Addendum to Basement Impact Assessment Report

Site	31 St Marks Crescent, London, NW1 7TT
Client	London Basement
Date	March 2019
Our Ref	ADDBIA/8084A

Addendum to Basement Impact Assessment

Site: **31 St Mark's Crescent,
London,
NW1 7TT**

Figure 1: Extract from Farrell Design Studio's Drg No.IND-1114-C01 showing comparison of approved (blue) and proposed (green) basement outlines at the rear of the property.

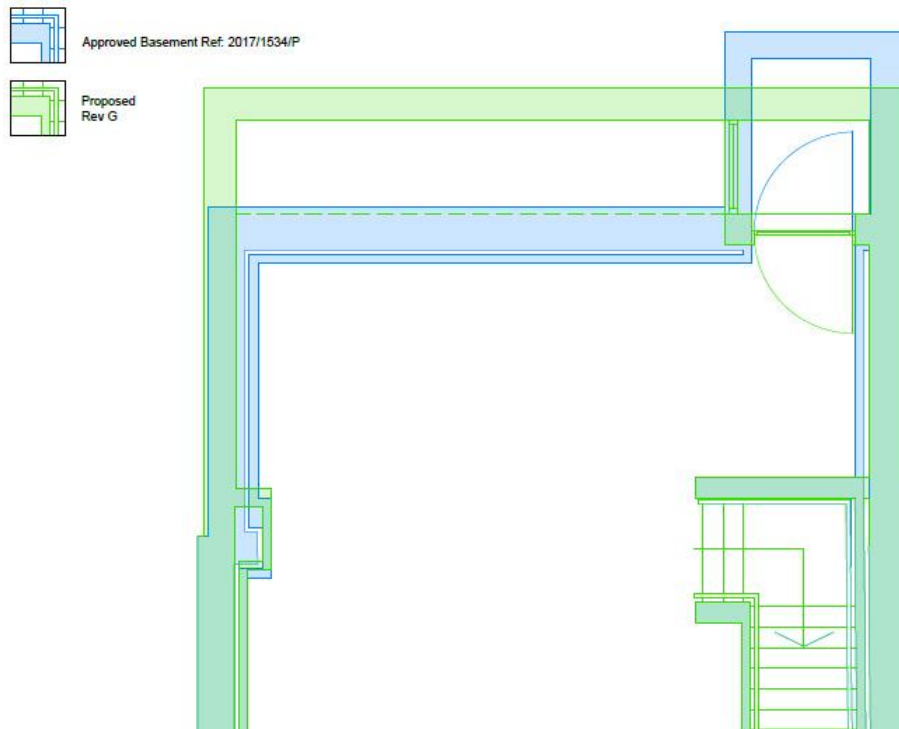
3.3 The proposed alterations to the approved scheme, as shown in Farrell Design Studio's (FDS) drawings (see paragraph 1.4 and Figure 1 above), include:

- Full width extension of the proposed basement by 1.3m to the rear, giving a total basement length, from the front wall of the front bay to rear wall, of 15.6m.
- The rear lightwell reduced in size and aligned to rear wall of basement, so no longer projects beyond the rear wall of the basement.
- At lower ground floor level, construction of a single storey rear extension, extending 3.6m to the rear of the existing rear wall of No.31. This extension will have a rooflight and terrace above accessible from ground floor level.
- Removal of walls separating the three vaults at the front of the property at lower ground floor level, to create a single 'storage' area, and other minor internal alterations at lower ground floor level and above, none of which are significant to the basement.

The front of the approved basement and internal access staircase remain the same.
